ACOUSONDE™ ATTITUDE/HEADING AXIS CONVENTION UPDATE

Model B003A and B003B

Firmware version 2.0.14, PalmOS client software version 2.0.3
January 2011

GREENERIDGE SCIENCES, INC.

Figure 1. Acousonde accelerometer and compass axes as configured in 2011.

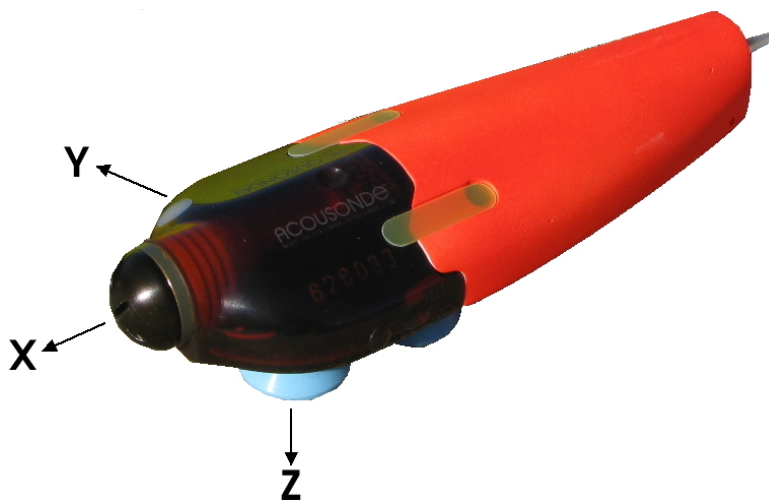
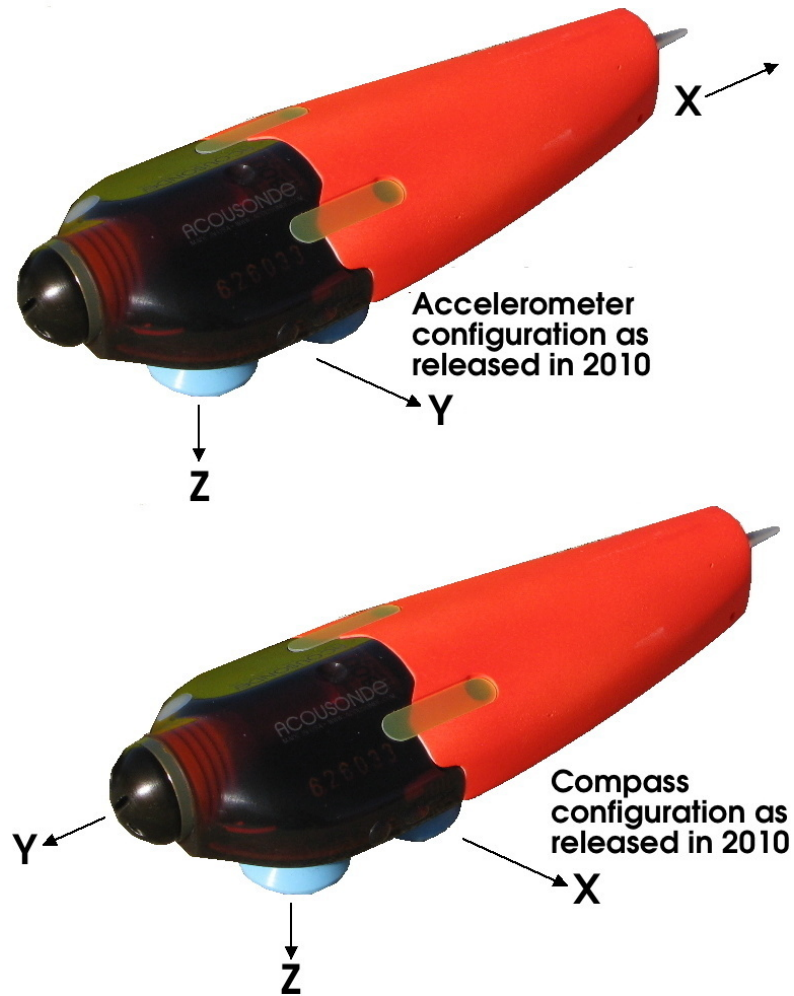
Marine navigation systems typically adopt the “north, east, down” reference-frame convention to represent attitude and compass heading. Acousonde units released in 2011 and after use axis conventions optimally compatible with this standard (Figure 1).

Alignment of the compass X, Y, or Z axes towards north yields positive samples in the corresponding channel. Samples from the X channel will be near maximum when the Acousonde points north; from the Y channel when the Acousonde points west; and from the Z channel when the Acousonde’s bottom points north.

Accelerometer X, Y, and Z* channels yield positive samples when the device is accelerated in the corresponding direction. Since gravity is equivalent to acceleration away from the Earth, it will induce positive samples on X when the Acousonde is pointed up; on Y when the Acousonde is positioned horizontally on its left side (i.e. 90° left roll); and on Z when the Acousonde is upside down.

Acousonde units released in 2010 and before use alternate axis definitions (Figure 2). Acoustimetrics recommends that all pre-2011 units be updated for maximum compatibility. Updating may be less important for users who foresee no kinematic applications.
